Rubber Avenue Reconstruction FY24-B057 NAUGATUCK, CONNECTICUT

ADDENDUM NO. 2

7-6-23

DET-15
 SHEET OF

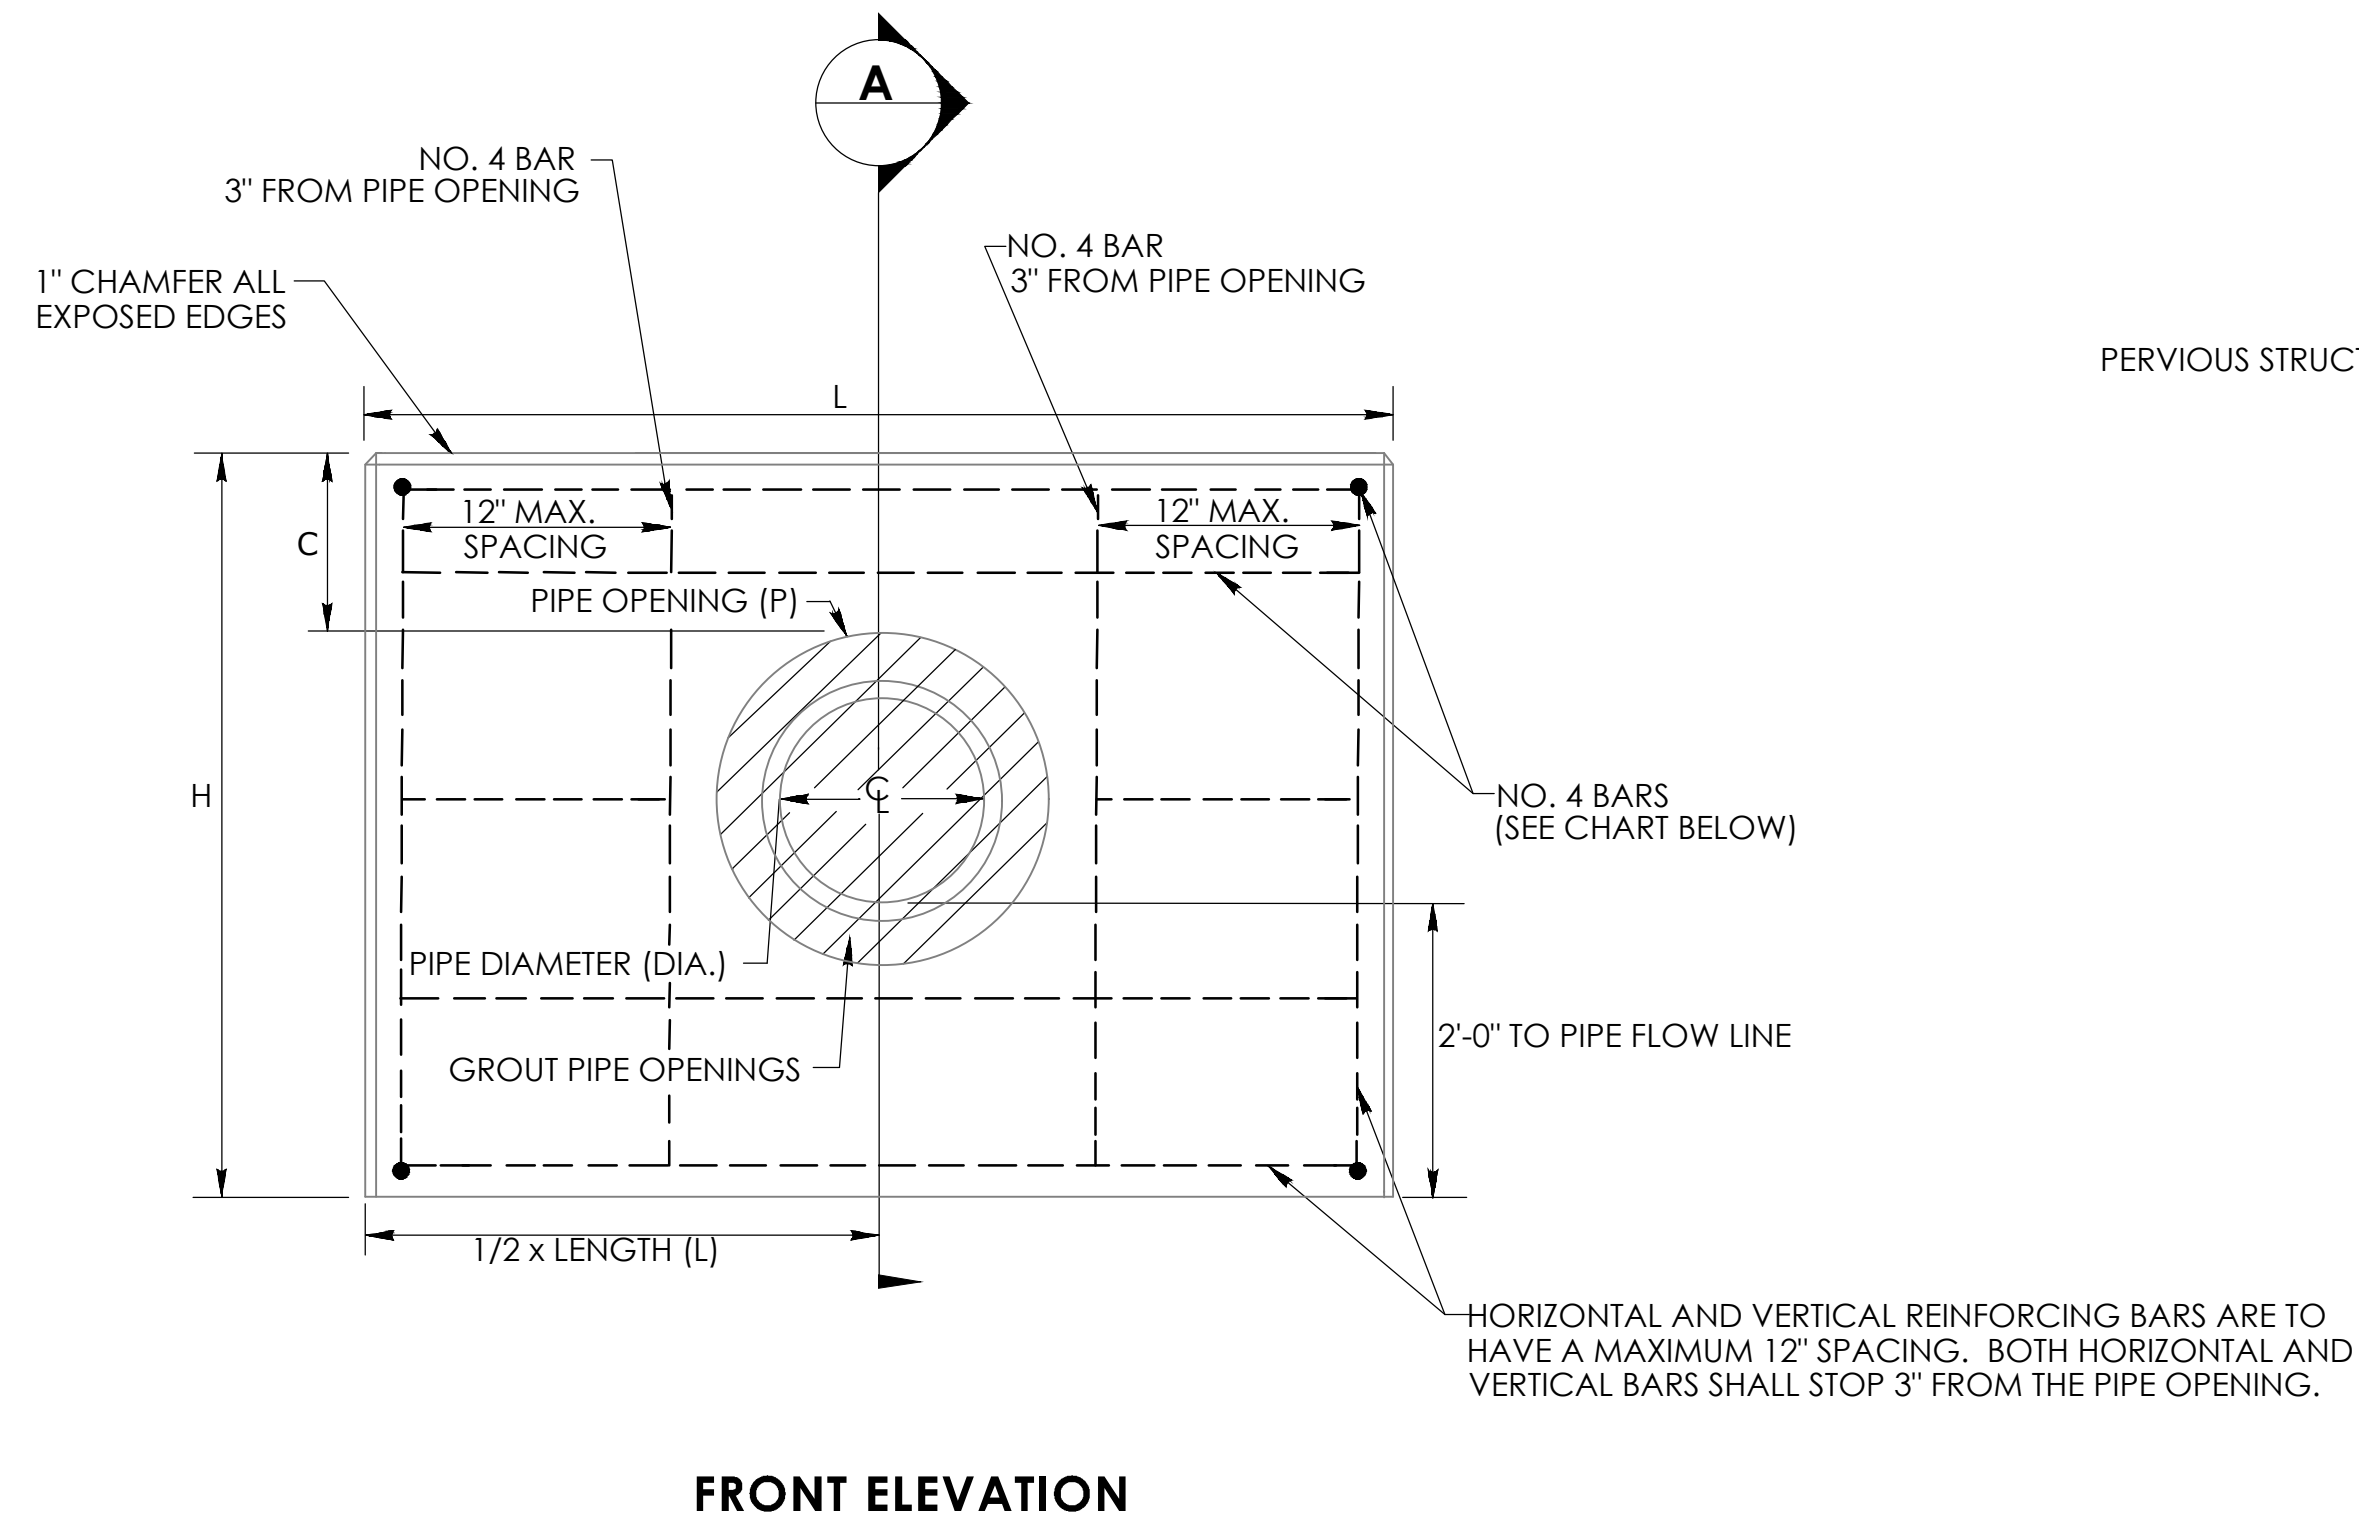
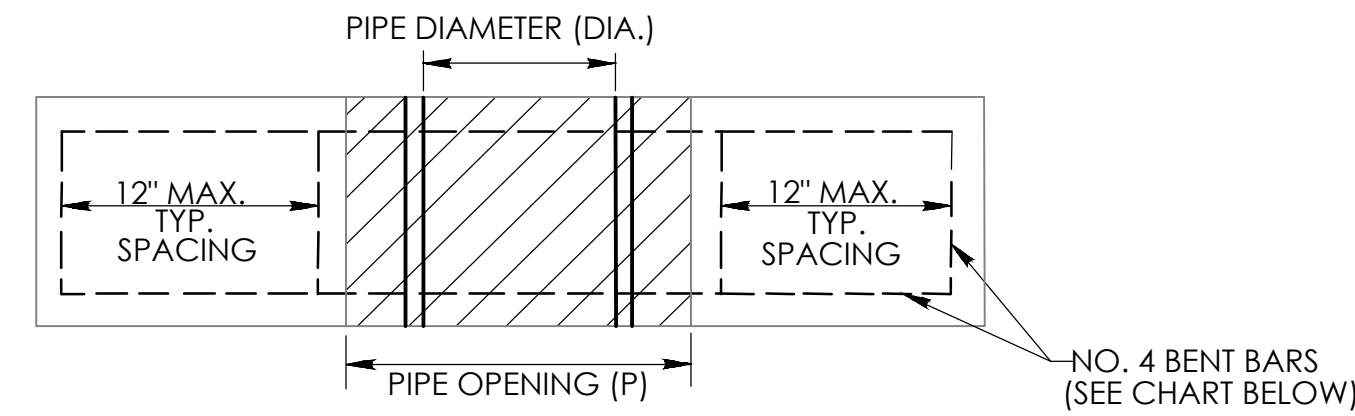
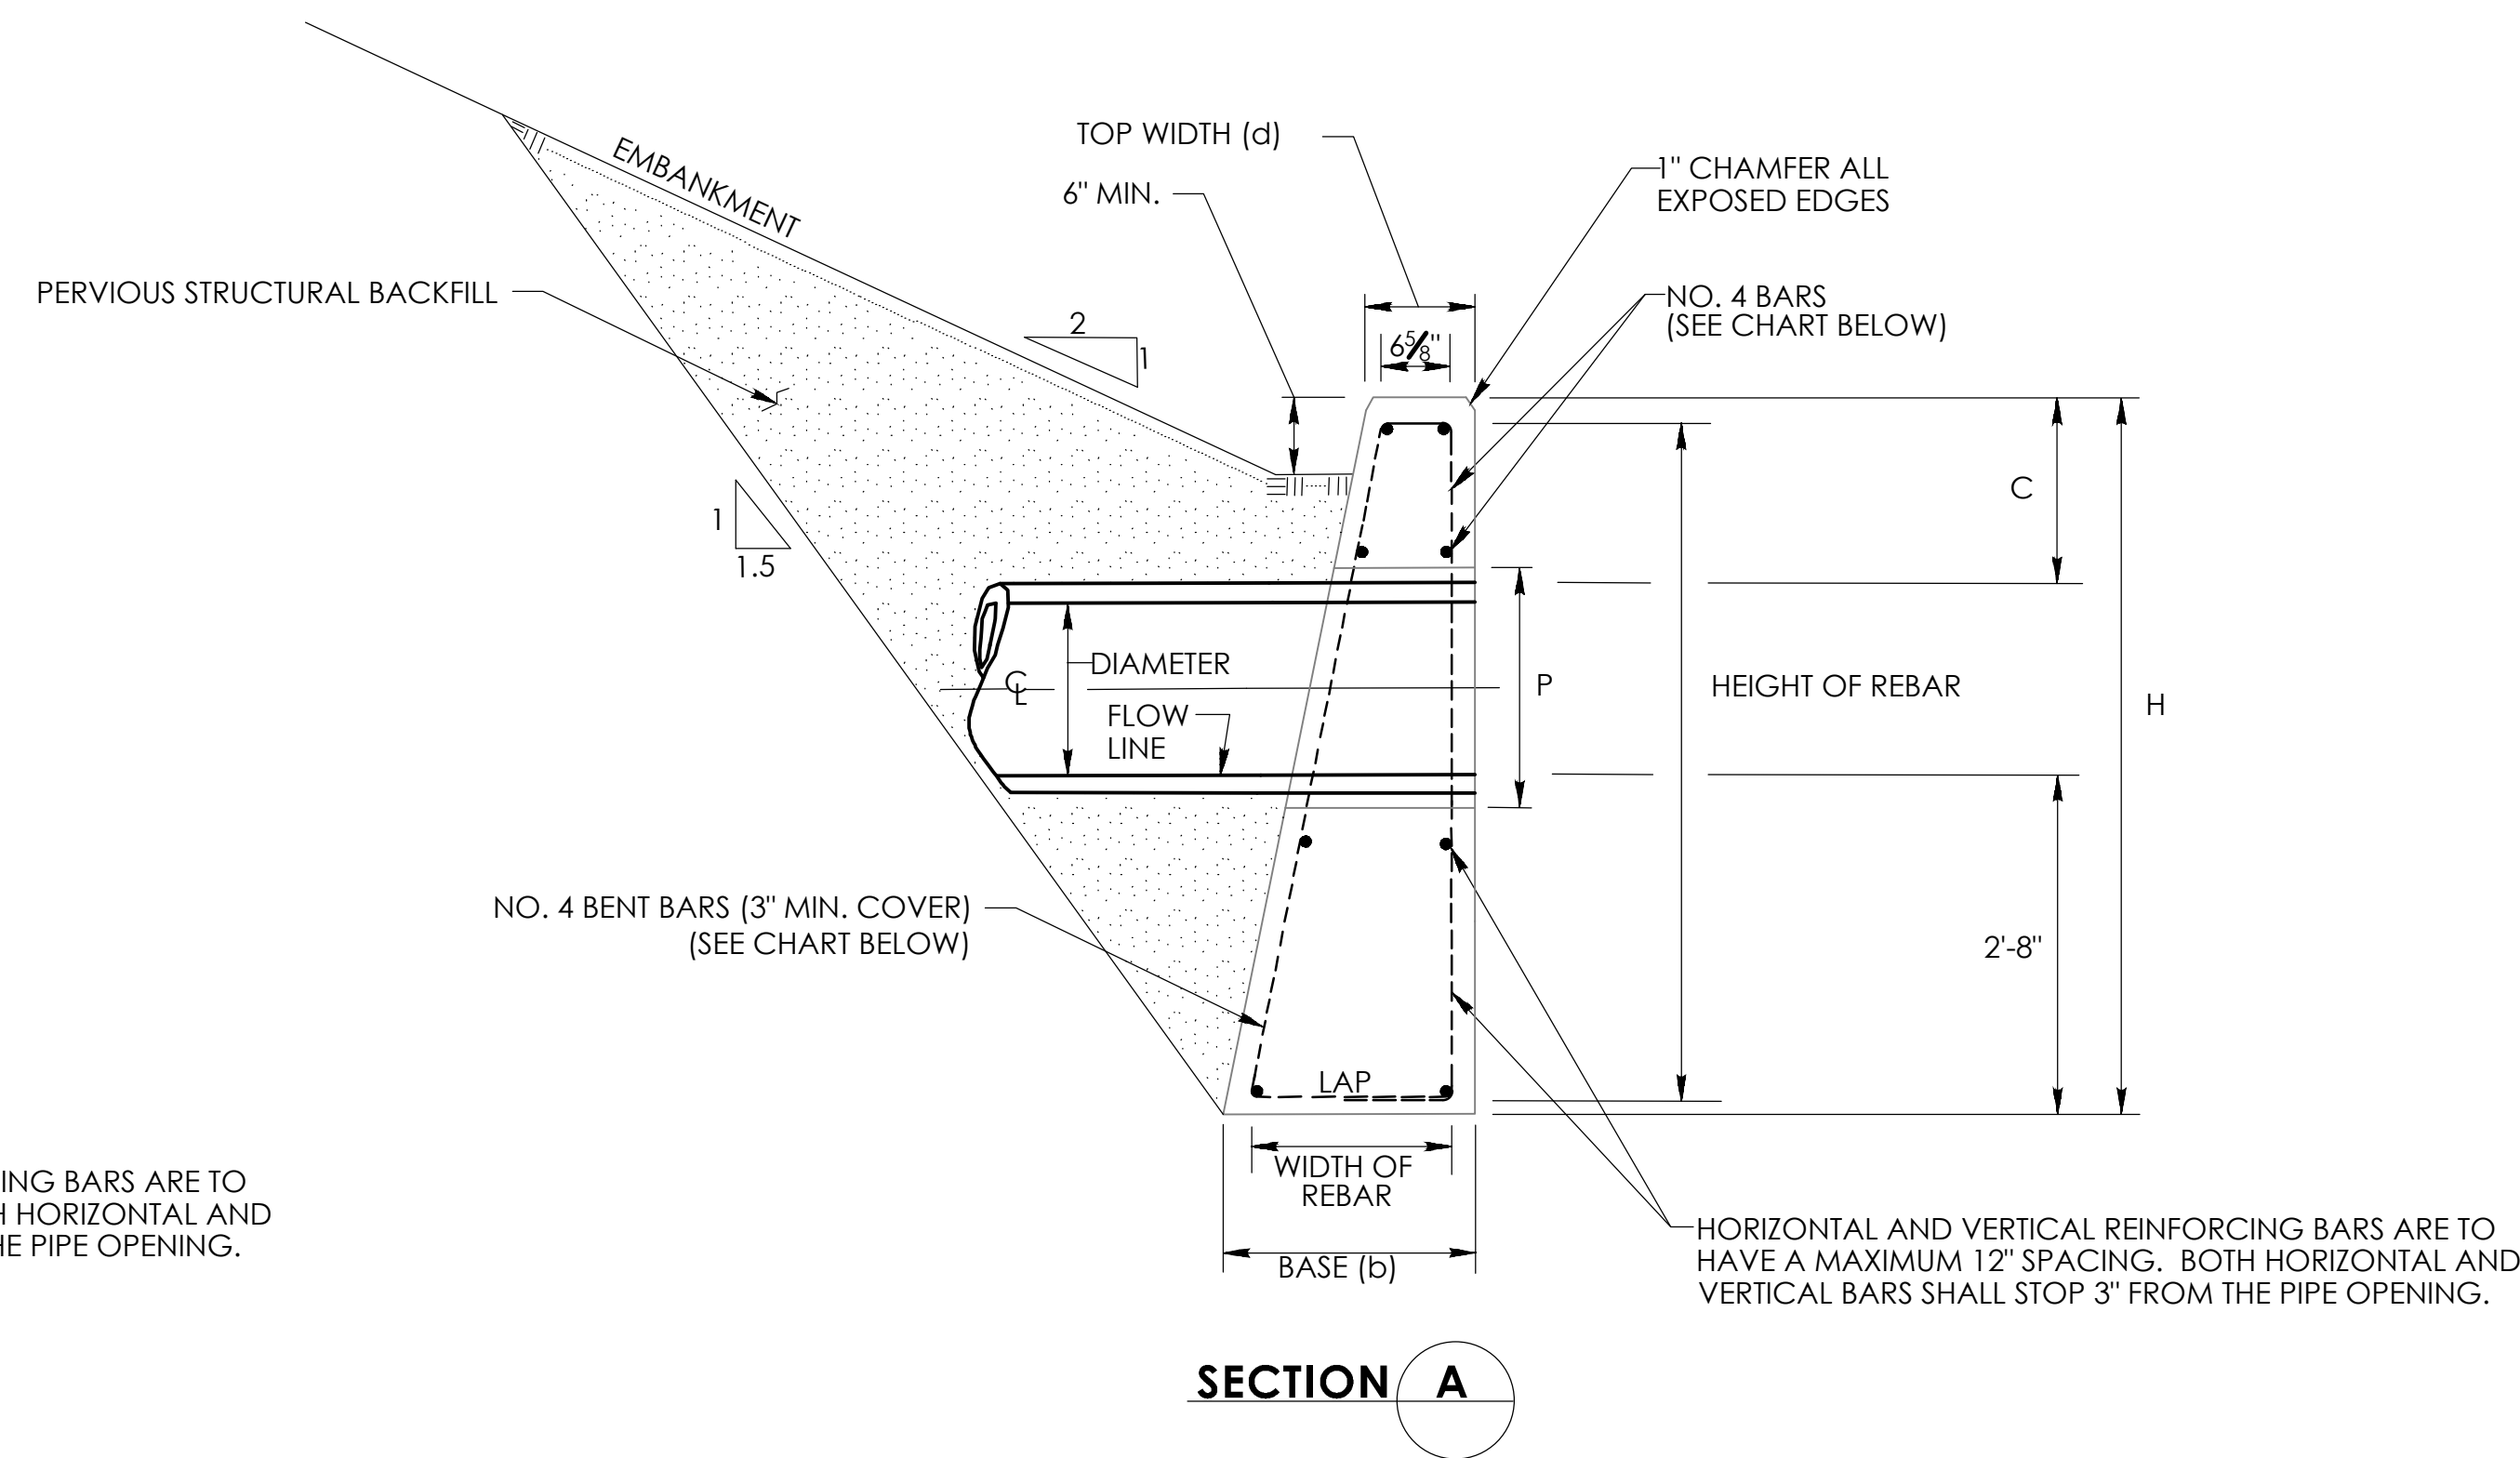
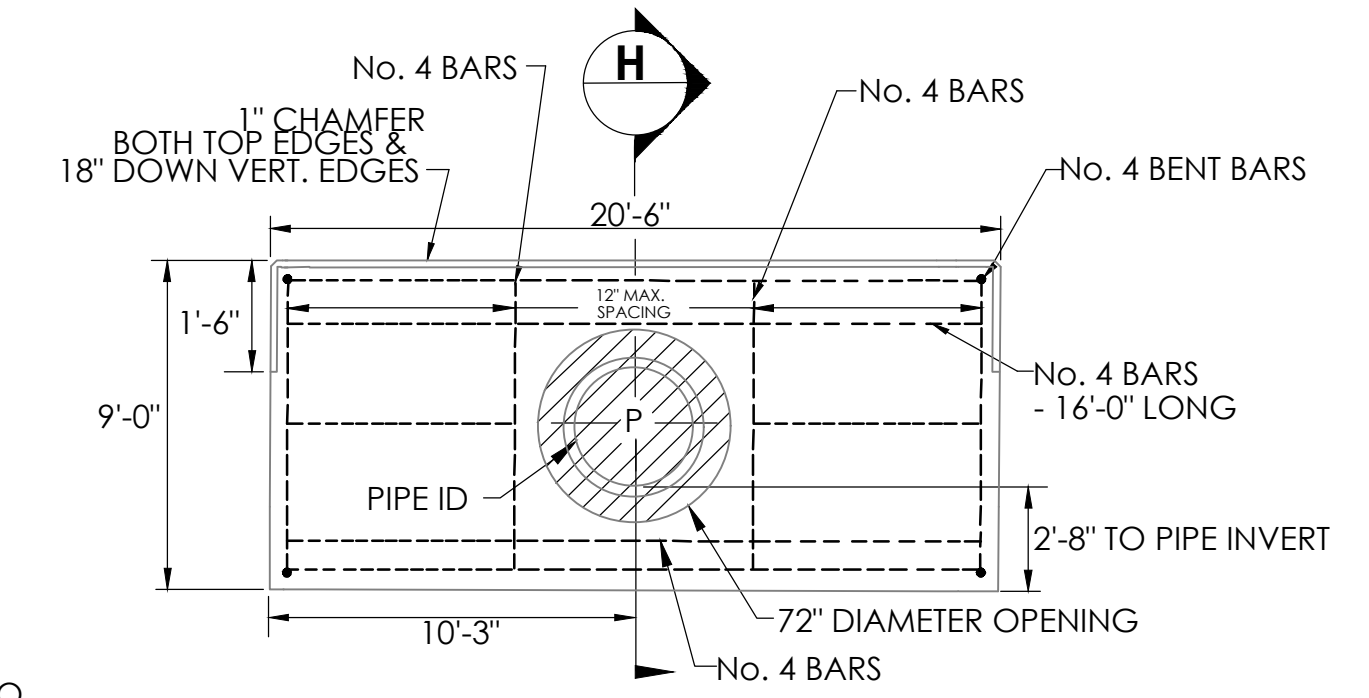
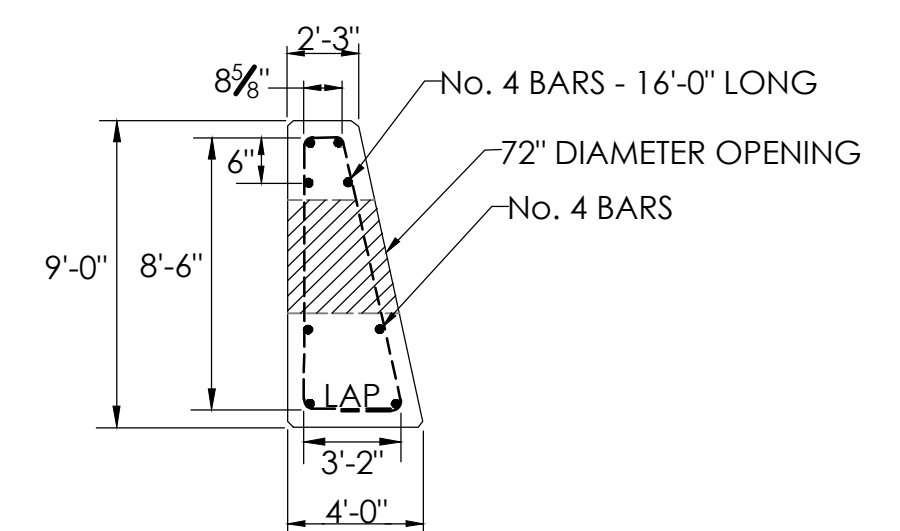
- p. Item #0751898 Concrete Endwall has no detail sheet describing the size, reinforcing, etc. The detail on Sheet 8 is incorrect and shows a precast concrete flared end section with a cut-off wall instead. This endwall has to be sized for a 60" RCP as shown on Sheet 38 of 115.

Response: See attached detail
